**IMPORTANT**

NEW MODEL - 26ER8BA

The following updates are required for the user of this Manual to reflect changes in the RIDER MOWER on Models 26ER8BA.

191B4618 R-0

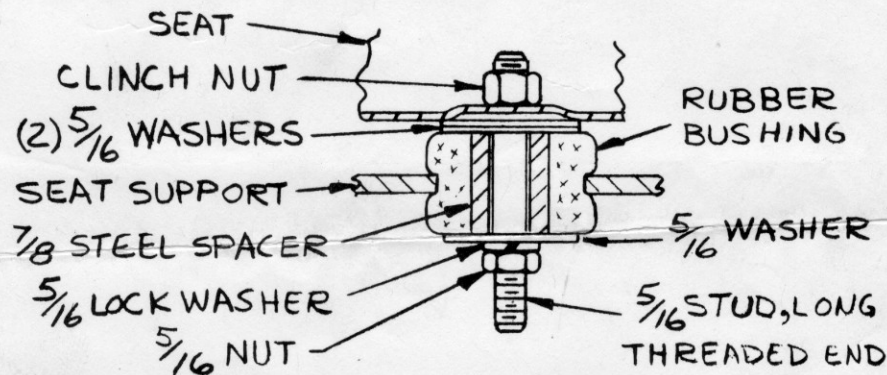
1. The method of mounting the seat to the RIDER (Page 20, Figure 22) is changed to the following procedure.

SEAT MOUNTING: THE ER8-36 RIDER USES A SEAT SWITCH FOR OPERATOR SAFETY TO INSURE PROPER OPERATION OF THIS DEVICE ASSEMBLE SEAT AS SHOWN.

INSTALL STUDS (SHORT THREADED END) INTO SEAT. WRENCH ON NON THREADED PORTION OF STUD. BOTTOM THREAD AGAINST SEAT CLINCH NUT. TIGHTEN  $\frac{5}{16}$  NUTS SUCH THAT THE RUBBER BUSHINGS ARE FULLY COMPRESSED AND THE FLAT WASHERS BOTTOM ON THE  $\frac{7}{8}$  LONG STEEL SPACER.
